**From:** Lauridsen, Keld B - DNR  
**Sent:** Thursday, August 29, 2019 3:56 PM  
**To:** 'Maletzke, Jeff'  
**Cc:** Cole, Albert; Mrotek, Melissa (GBY); Romback-Bartels, Jean - DNR; Chronert, Roxanne N - DNR; Kelly, Bridget B - DNR  
**Subject:** RE: GP Broadway Mill Expansion - BRRTS # 02-05-583452

**From:** Maletzke, Jeff <[Jeff.Maletzke@aecom.com](mailto:Jeff.Maletzke@aecom.com)>  
**Sent:** Friday, August 9, 2019 1:04 PM  
**To:** Lauridsen, Keld B - DNR <[Keld.Lauridsen@wisconsin.gov](mailto:Keld.Lauridsen@wisconsin.gov)>  
**Cc:** Cole, Albert <[Albert.Cole@aecom.com](mailto:Albert.Cole@aecom.com)>; Mrotek, Melissa (GBY) <[MELISSA.MROTEK@GAPAC.com](mailto:MELISSA.MROTEK@GAPAC.com)>  
**Subject:** GP Project Pace work plan

PROJECT: Pace PM02			
MACH NAME: Balance of Plant			
DET NAME: CONFIRMATION SAMPLE LOCATIONS			
DR.	MTP	CH.	JM
-	-	-	-
DATE: 8/20/19		-	
AECOM #: 2.01		JOB #: 60601464	
FIGURE 1			REV A
DWG #: CONFIRMATION SAMPLE LOCATIONS

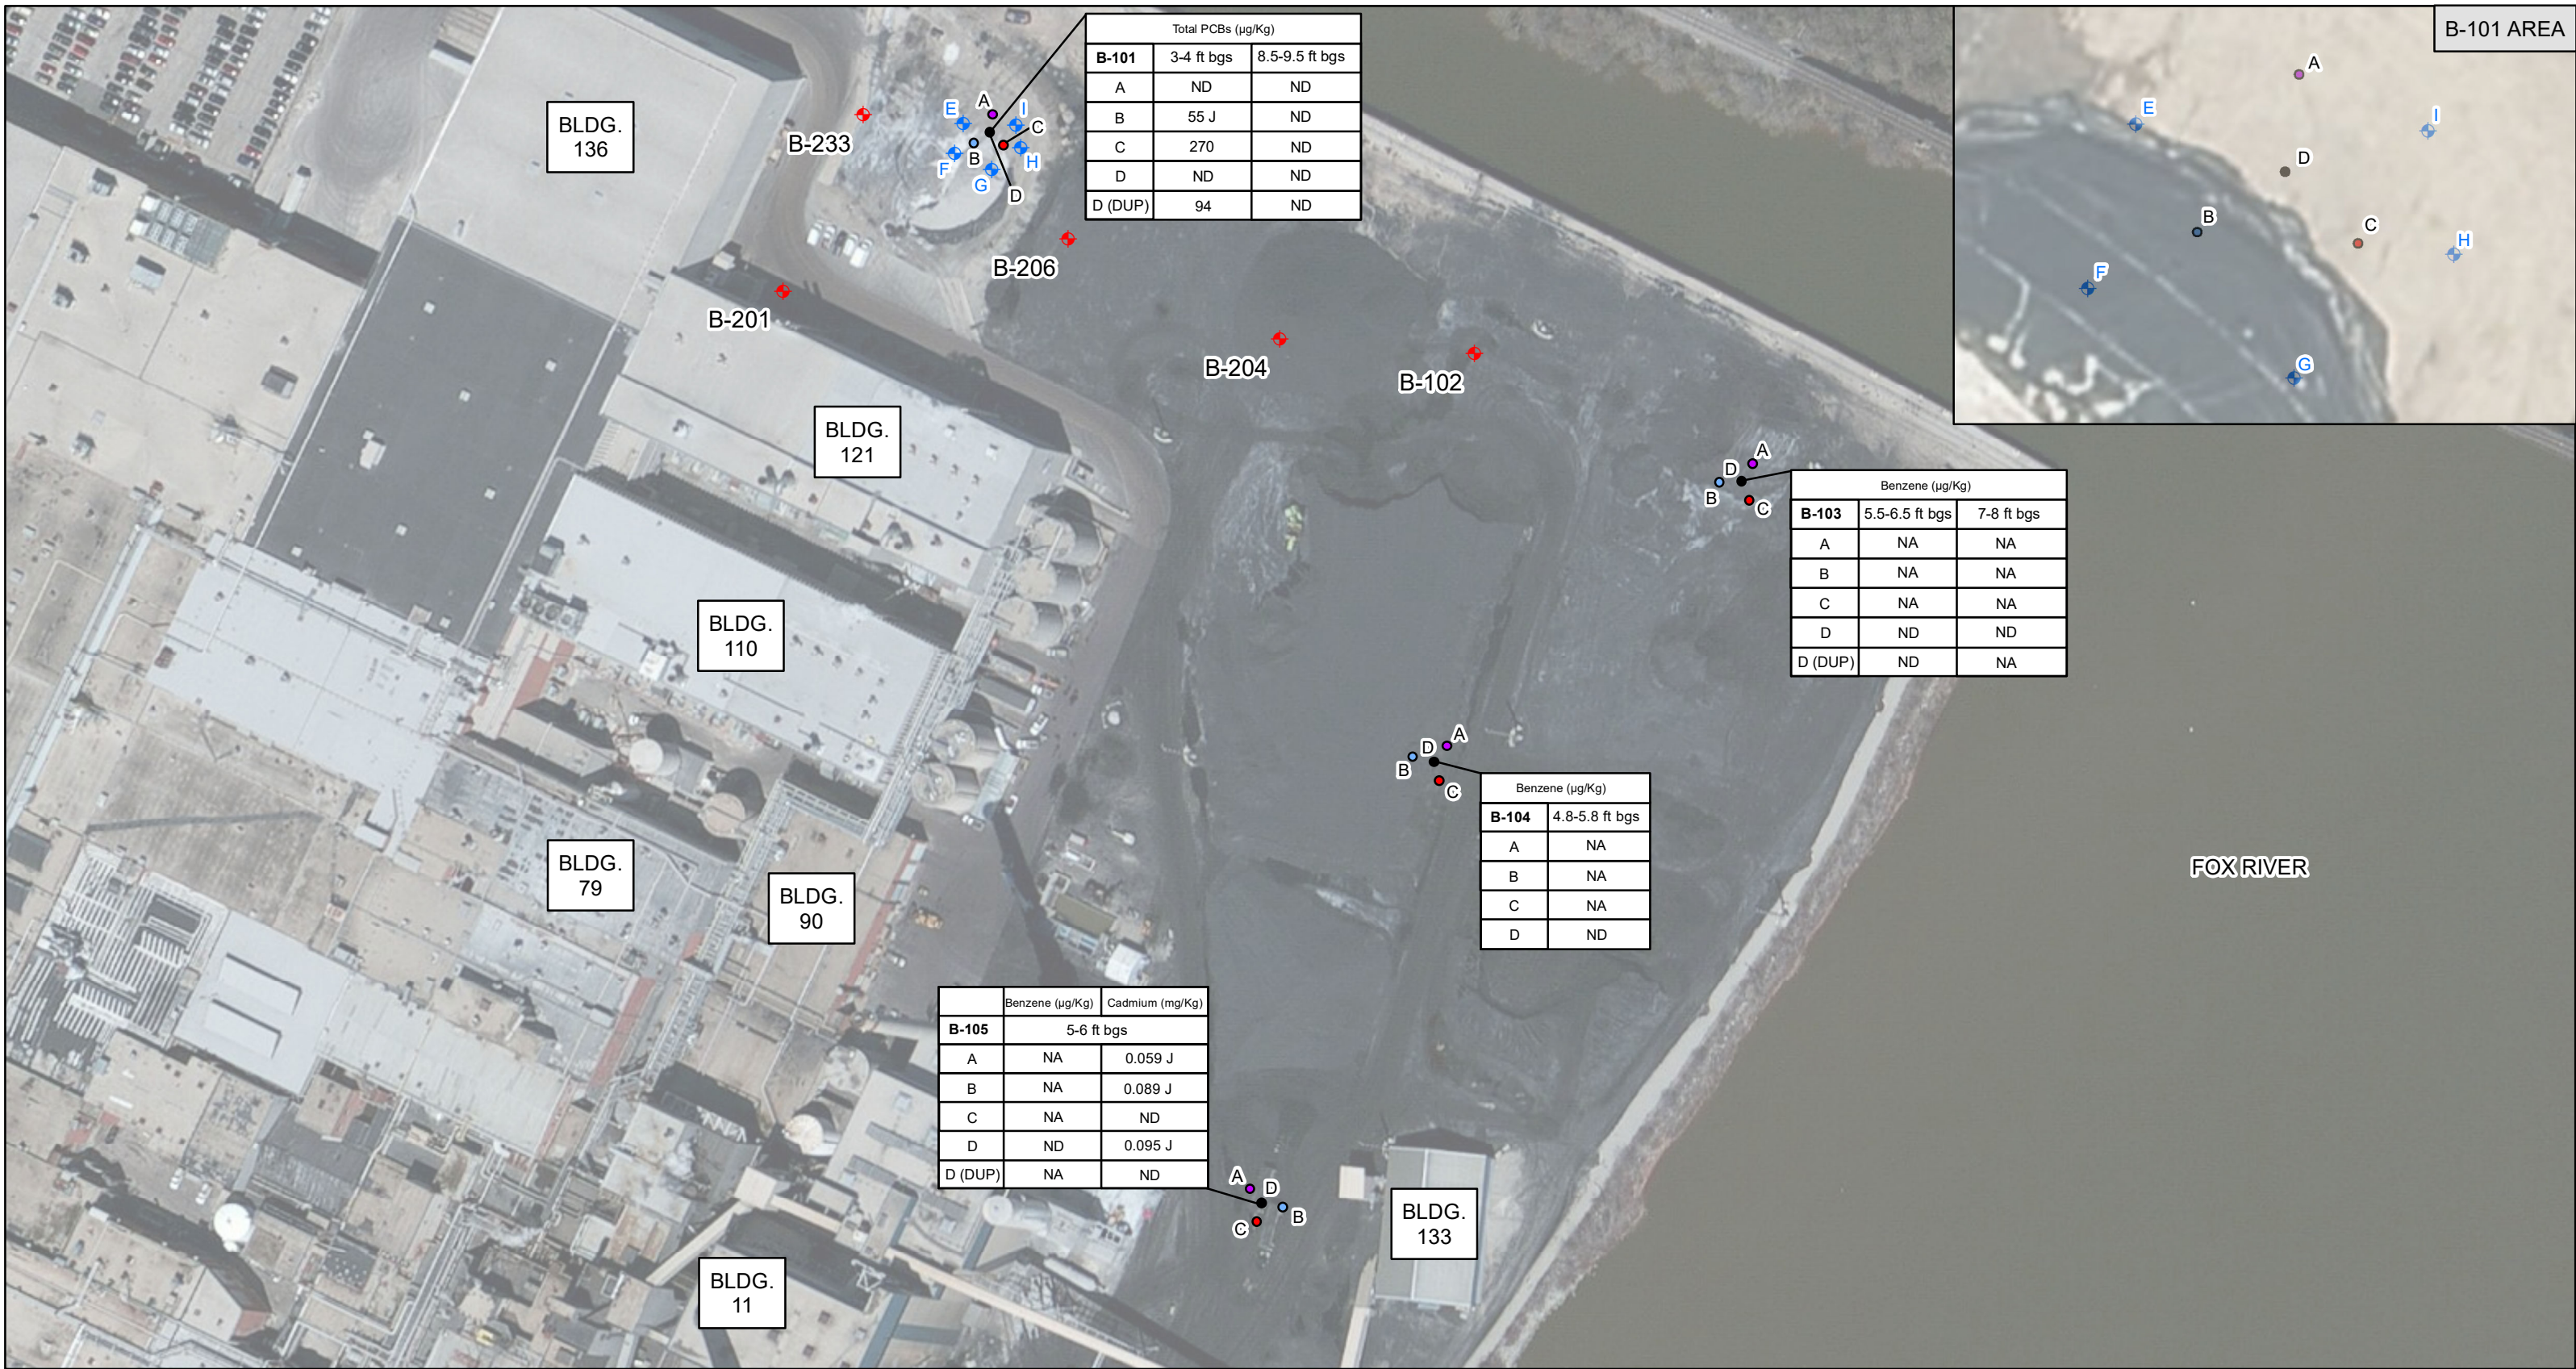
DNR concurs with the proposed revised soil sampling locations. When the analytical data is available, please provide lab sheets, an updated soil table and a map showing actual soil sampling locations as completed in the field.

Thank you Keld. I talked it over with Melissa and we adjusted the sample locations counter-clockwise as you suggested – please see attached. We also added one more sample (“I”). If the results of this sampling indicate the need for additional sampling we plan to remob and step out to collect the additional samples. Please provide your concurrence or additional suggestions regarding the proposed sample locations.

I have reviewed the available soil data for the above site and concur with your general approach collecting additional soil samples to further delineate the remaining PCB contamination in soil.

I discussed the proposed soil sampling locations with Melissa earlier today over the phone and I suggested to potentially move them counter clockwise in order to get a better handle on degree and extent prior to excavation of the contaminated soil. I also suggested to consider collecting additional soil samples (to be held by the lab) even further out in case PCBs are still present in any of the first set of soil samples. Hopefully, the proposed soil sampling will eliminate the need for post-excavation confirmation soil sampling.
